RE: 150 Steeles Avenue East and 248, 250 & 314 Martin Street, Milton, Proposed Mixed-Use Development

This memorandum is intended to provide additional information to address the Town’s transportation-related comments dated April 2, 2026 and April 8, 2026, and the Region’s transportation comments dated April 17, 2026, in regard to BA Group’s February 2026 Transportation Considerations Report (“the February 2026 BA Group Report”). We trust that the enclosed memorandum provides the appropriate information requested by the Town. Please feel free to let us know if you have any questions or require any additional information.

1.0 BA GROUP RESPONSES TO TOWN COMMENTS

OUTBOUND

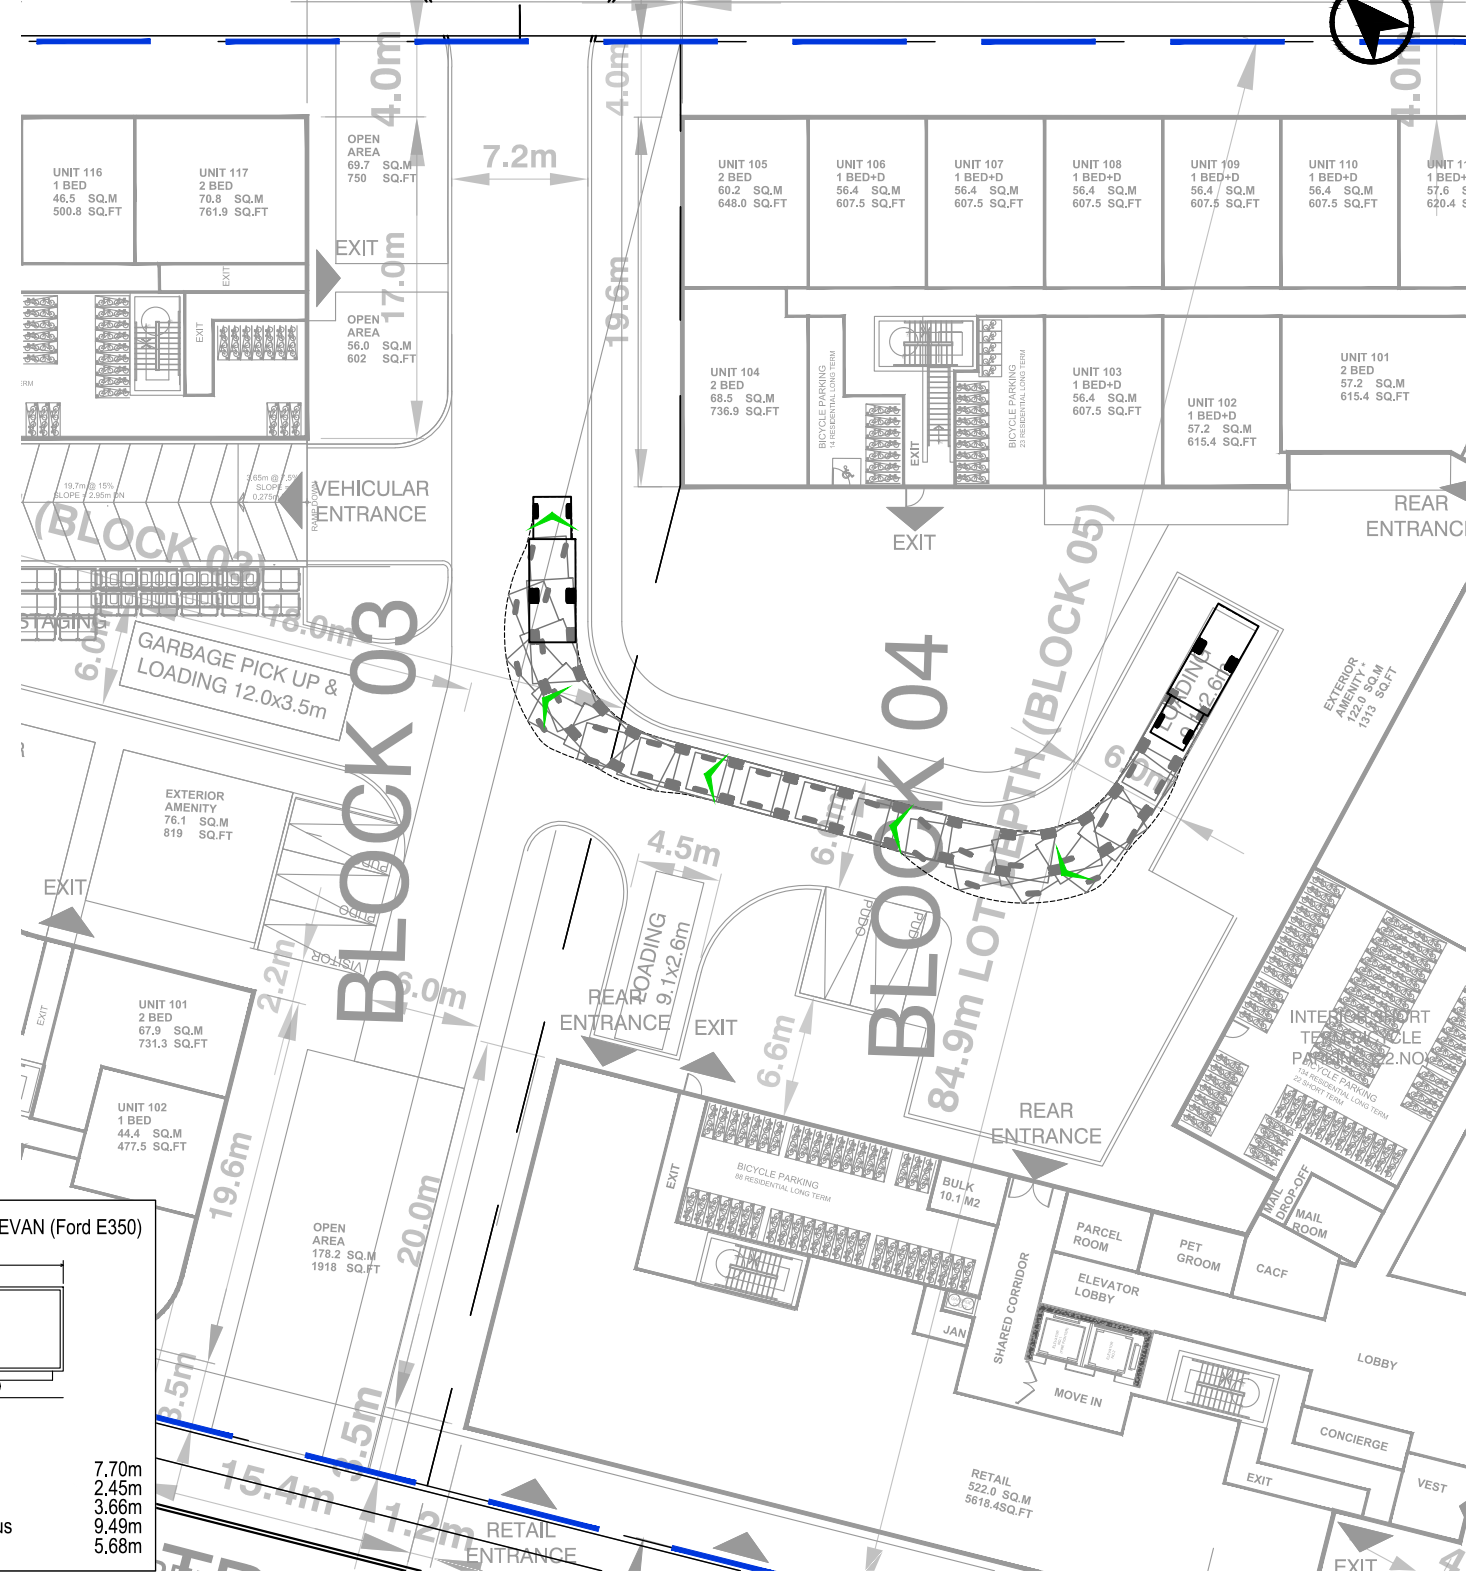
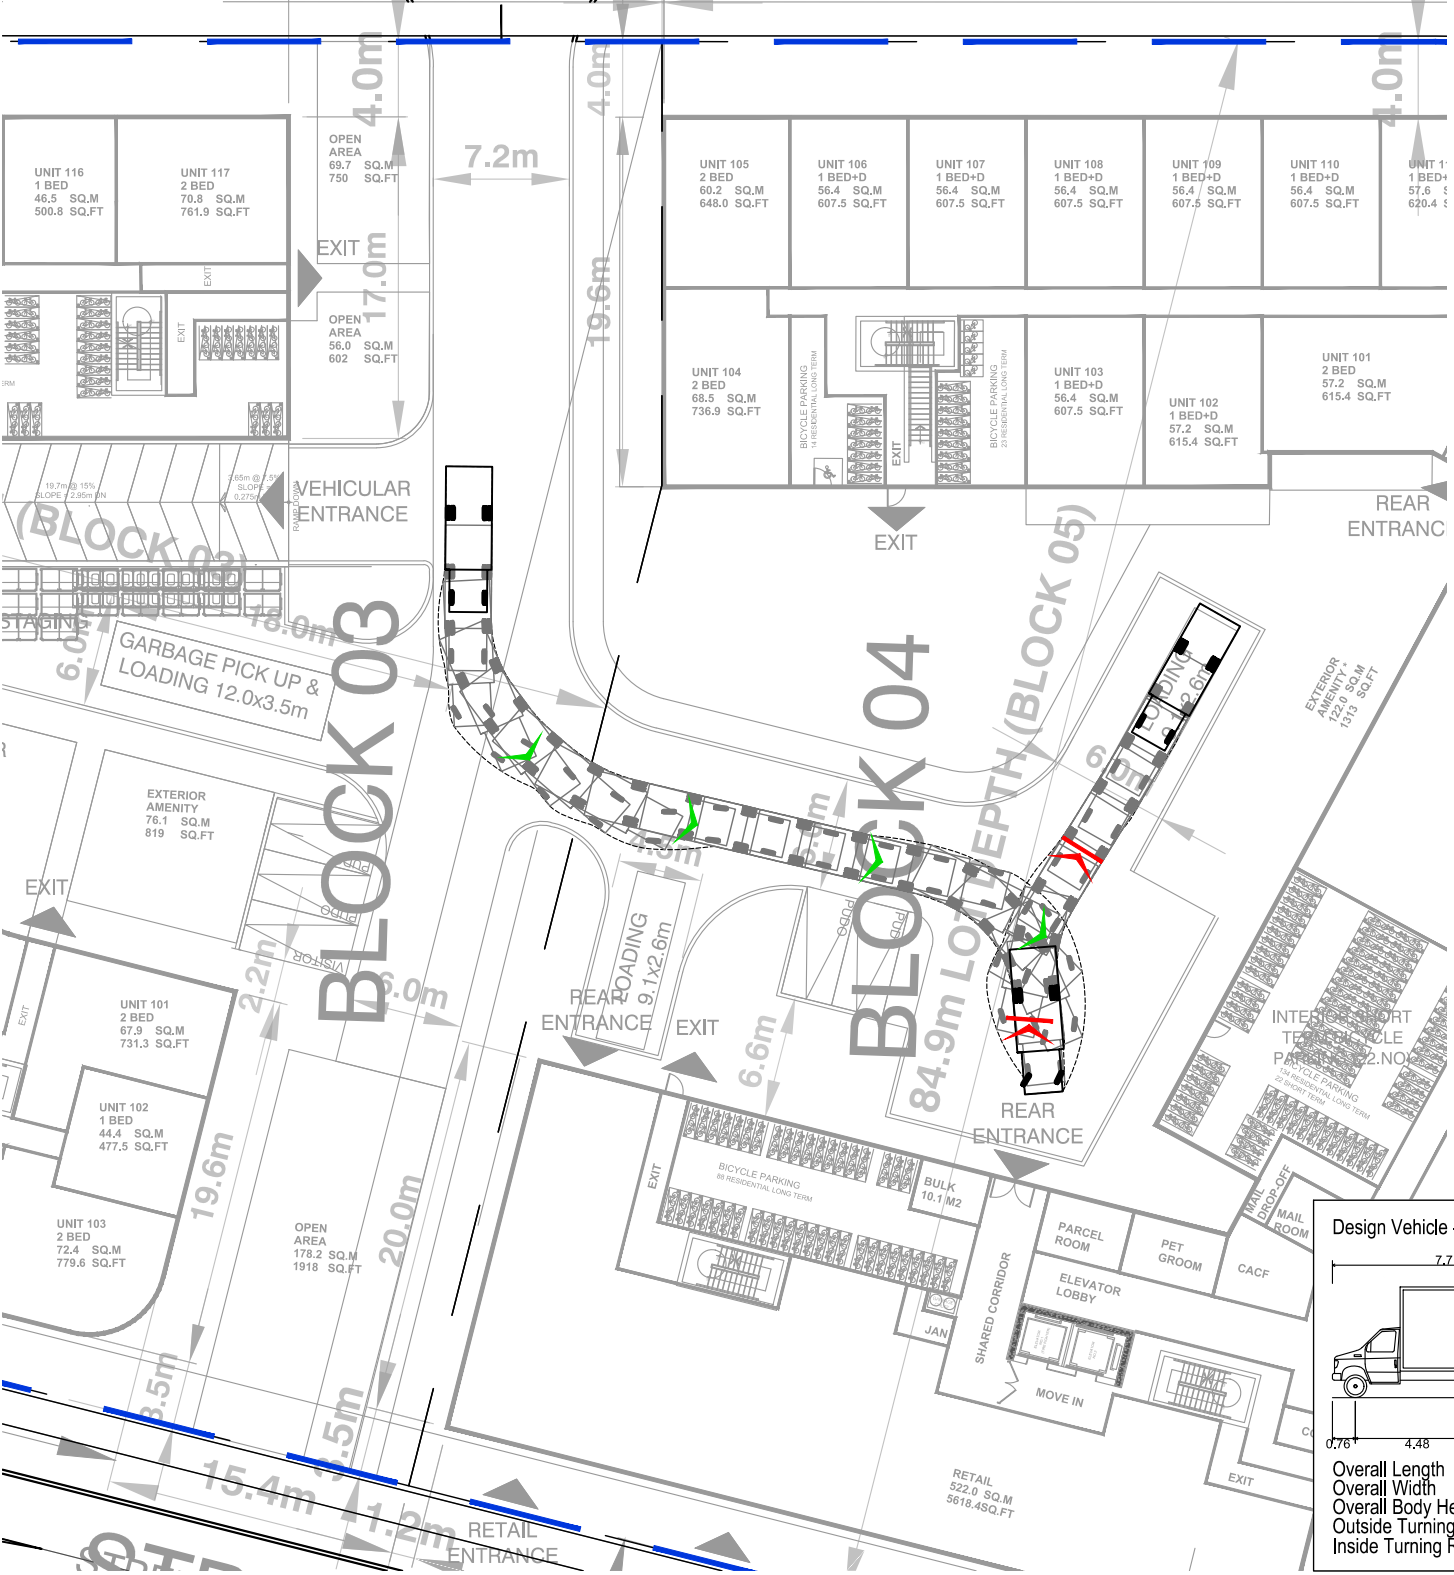
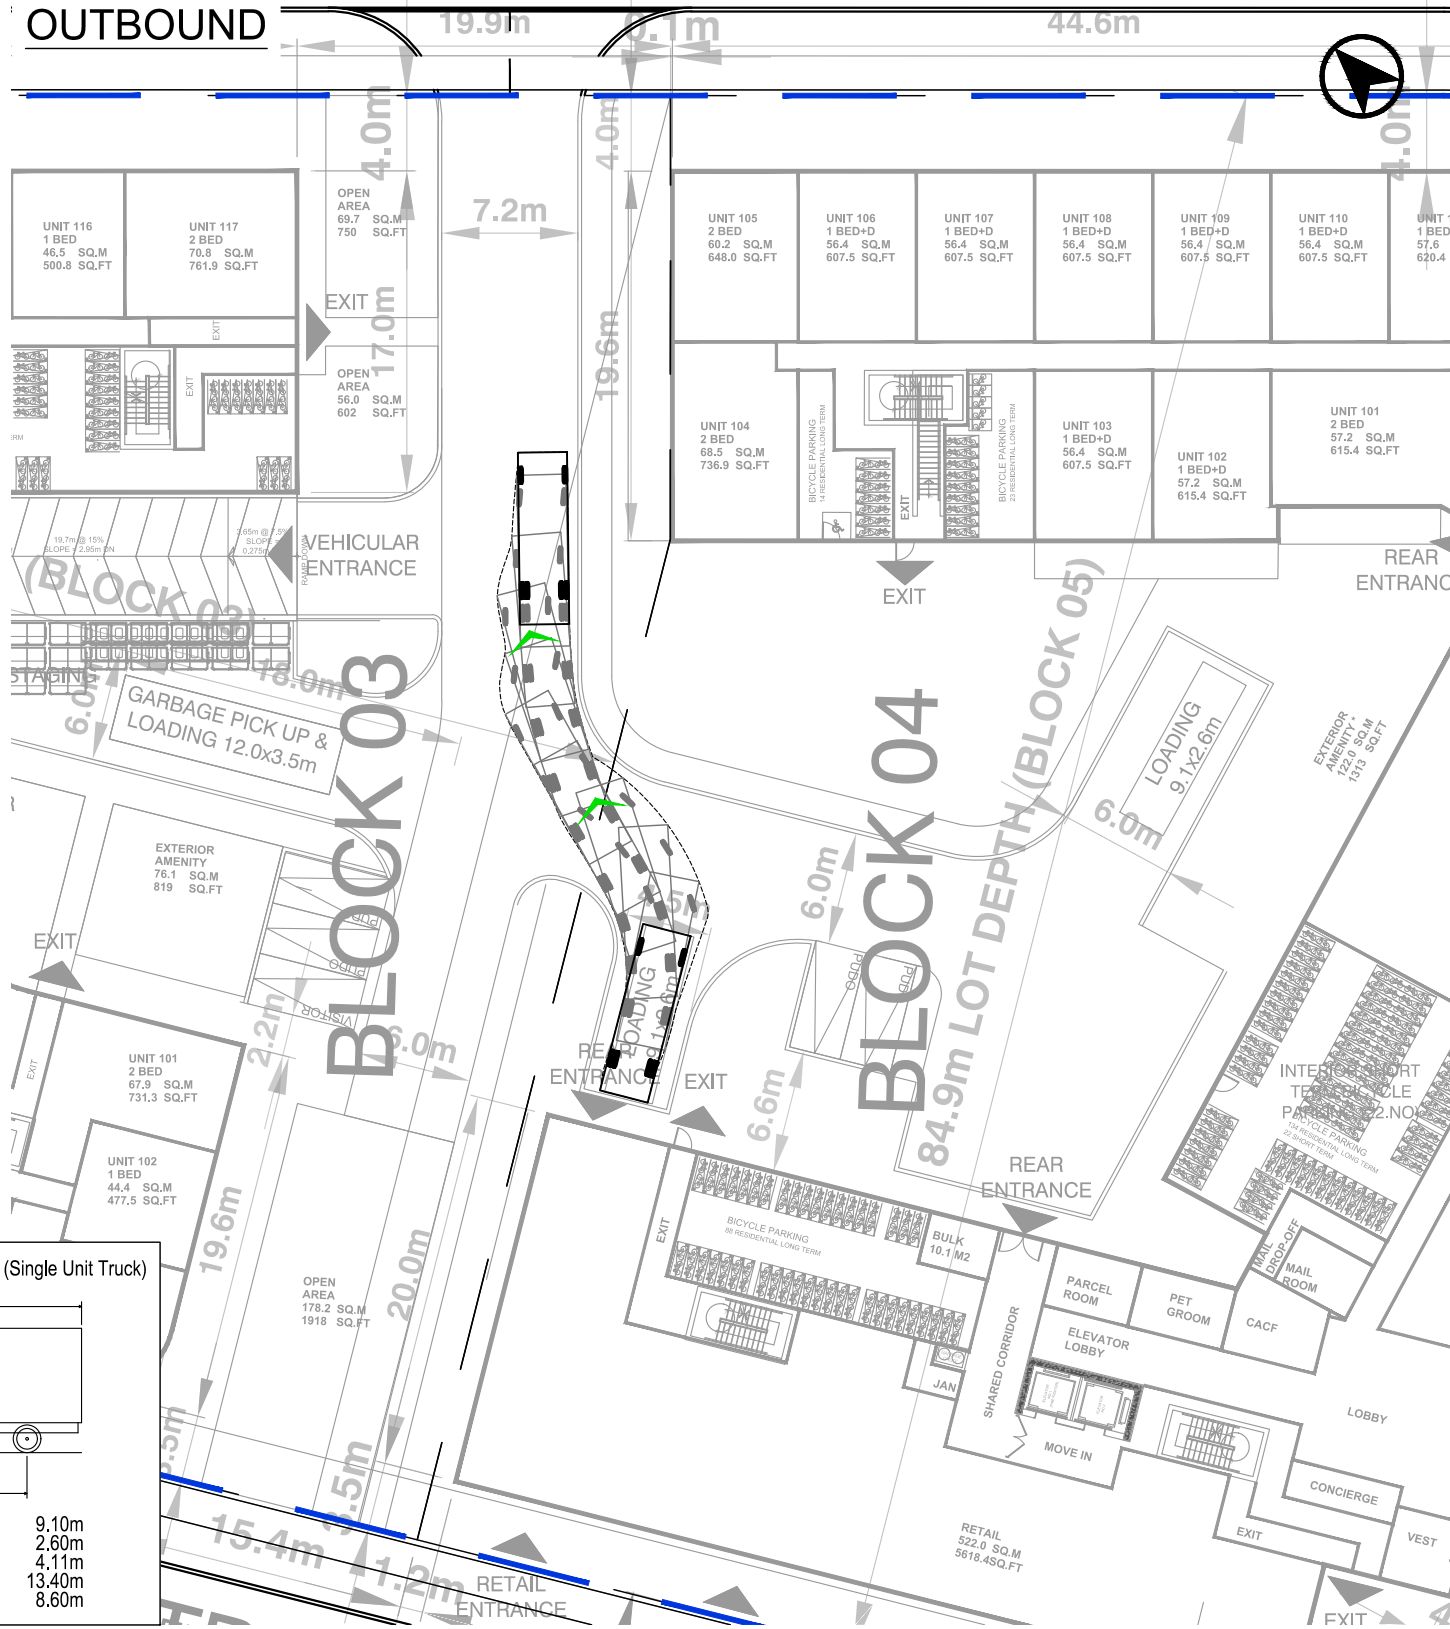
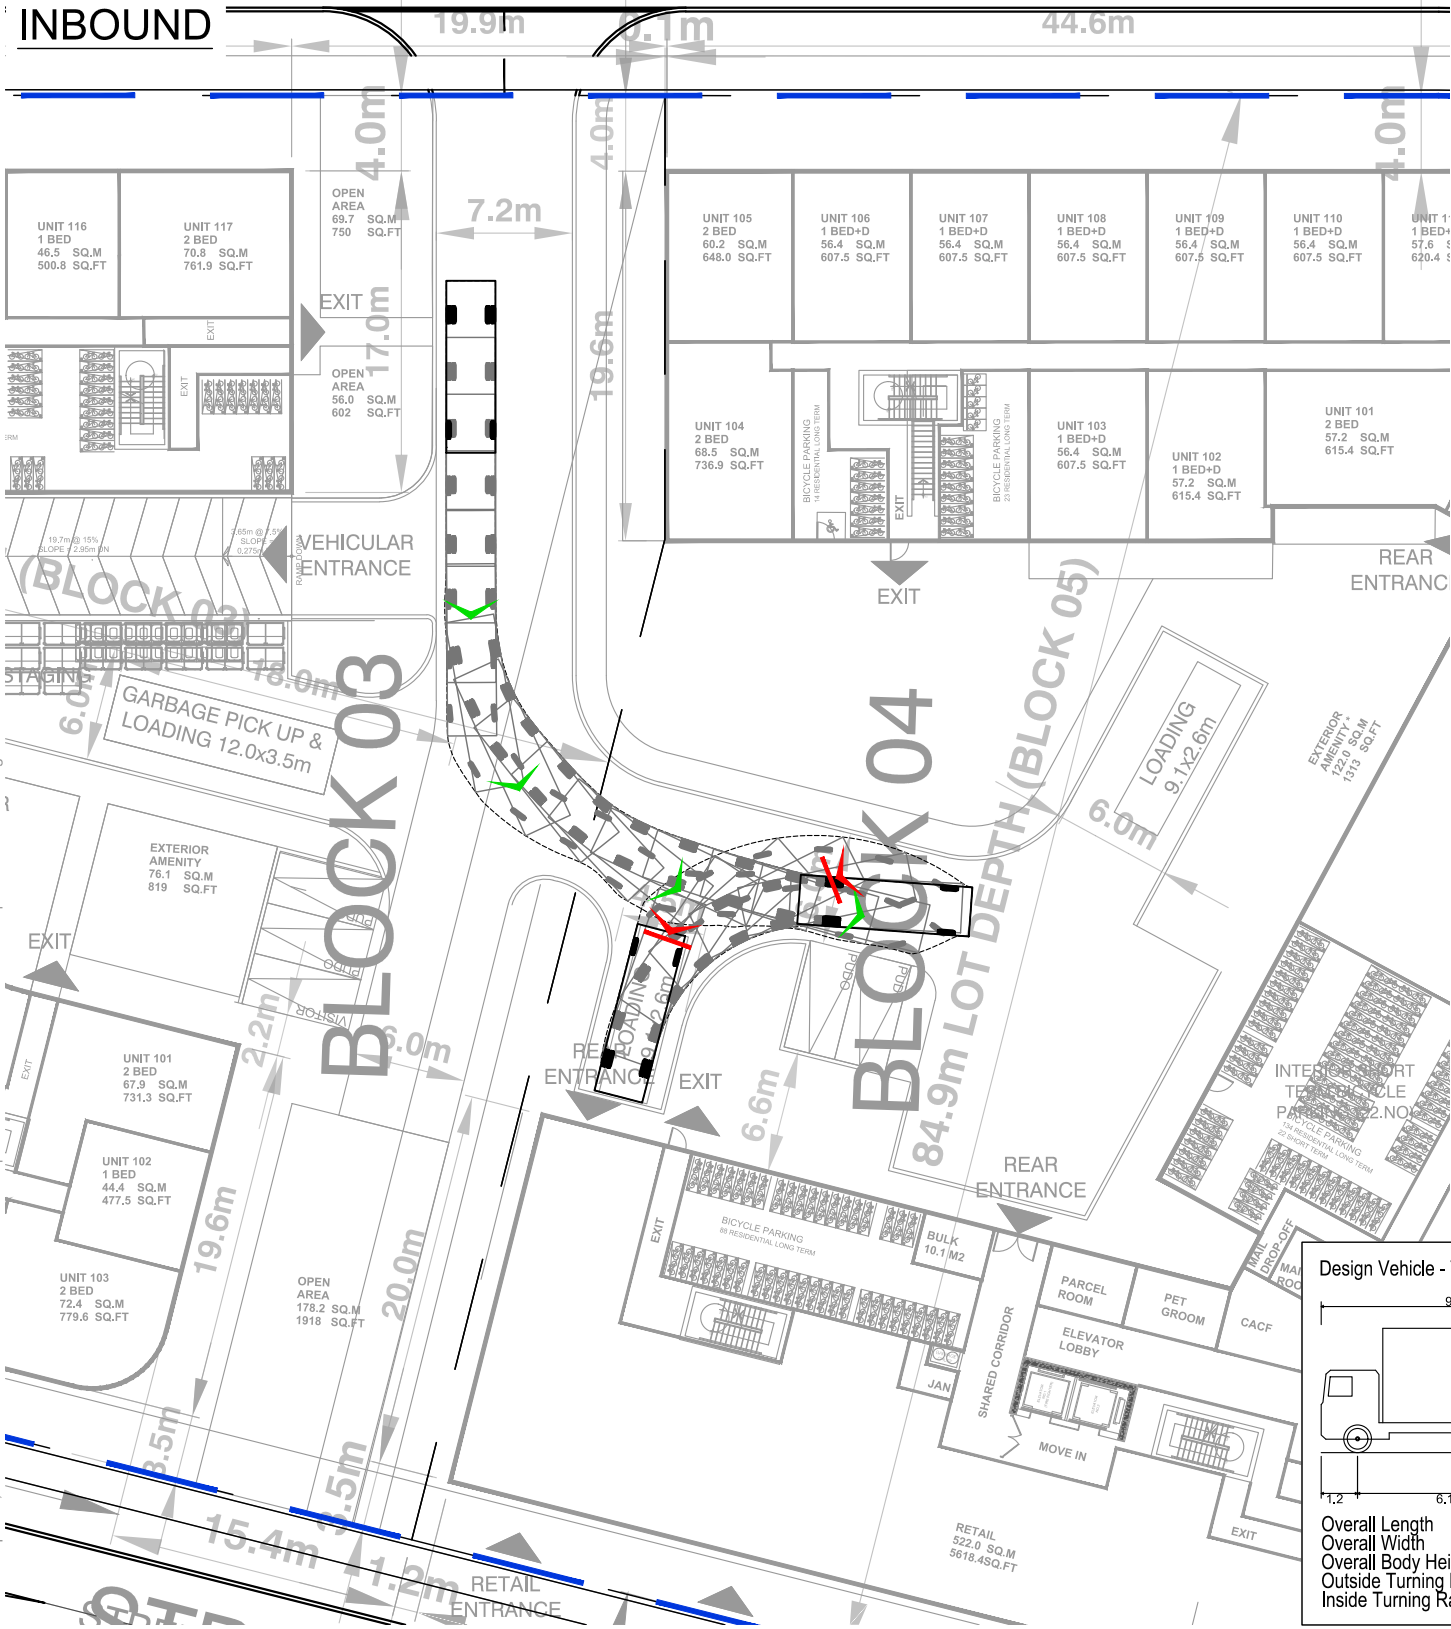
Comment: Please indicate the centreline turning radius in all locations where the waste collection vehicle is turning and approaching loading area (minimum 13 metres).

Comment: Please indicate the length of the head-on approach (minimum 18 metres).

Comment: Please indicate the distance the waste collection vehicle will be required to reverse (maximum 18 metres).

Comment: Please indicate the waste collection vehicle route from the municipal road to the Collection Point and back to the municipal road. Please ensure to include the turning radius of all turns.

Comment: Where continuous forward movement of waste truck cannot be achieved, a cul-de-sac or T-turnaround may be permitted if 13m turning radius and max 18 metre backup distances can be met.

Comment: Notwithstanding the loading requirements set out in the Town 's Zoning By-law, the loading spaces in Phase 1 of the development are proposed to be 12 m x 3.5 m (overhead waste collection) in size.

- All dimensions on the below loading areas including centre line turning radii.
- One truck maneuvering diagram. The overlay provided below makes it difficult to determine the path of the collection vehicle.

Response: The centreline turning radius of a minimum of 13 metres is illustrated on the Vehicle Manoeuvring Diagrams (VMDs) attached in **Appendix C**.

Response: The 18 metres head-on approach is illustrated on the VMDs attached in **Appendix C**.

Response: The reversal distance of the waste collection vehicle is illustrated on the VMDs attached in **Appendix C** and illustrate reversal distances of 18 metres or less.

Response: VMDs provided in **Appendix C** illustrate waste collection vehicles entering each block from the municipal road and leaving each block onto the municipal road.

Response: VMDs provided in **Appendix C** illustrate waste collection vehicles entering and existing each site in a forward motion. The turning radius (minimum 13 metres) and the reversal distances (maximum 18 metres) are illustrated on the VMDs.

Response: Vehicle Manoeuvring Diagrams provided in **Appendix C** illustrate the waste collection vehicle entering and exiting the proposed waste collection areas with dimensions (minimum 13 metres turning radius, minimum 18 metres head-on approach and maximum 18 metres reversal distance).
